Addendum #3

Fire Restoration- 43 & 60 William Warfield Drive
Four pages including this cover sheet

BID ADDENDUM NO. (3)

Harriett Tubman Estates Unit 43 & 60 Fire Restoration

1 NEW WORK - UNIT 60 - MECH ROOM PLAN
1/2" = 1'-0"

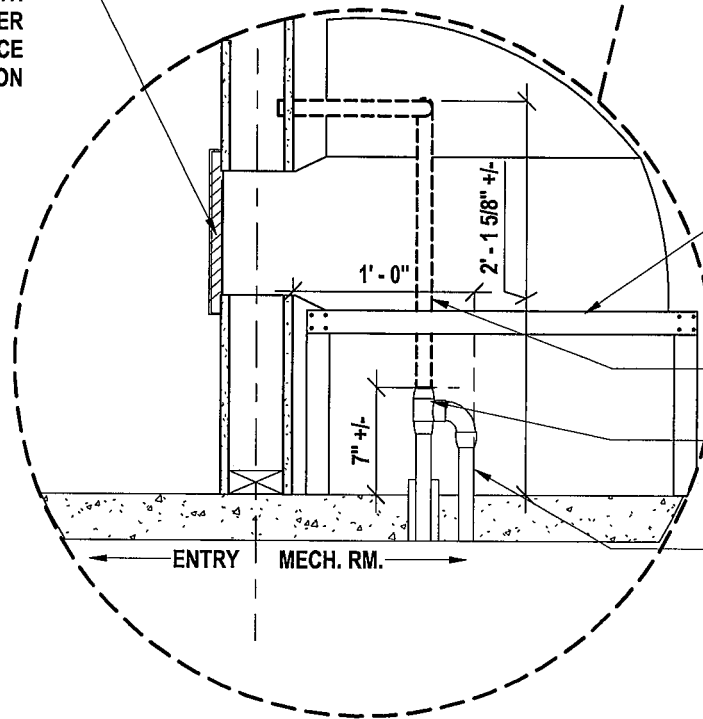
FURNACE TO PROVIDE
BOTTOM INTAKE WITH
THROUGH WALL LOUVER
VENT MEETING FURNACE
SPECIFICATION

PROVIDE METAL FURNACE STAND
TO SUPPORT NEW FURNACE AND
PROVIDE CLEARANCES FOR WATER
SERVICE LINE

DEMO UPPER PORTION OF
WATER SUPPLY PIPING

PROVIDE NEW SHUT OFF AND
ROUTING TO CONNECT TO
DCW AS SHOWN ON P-1
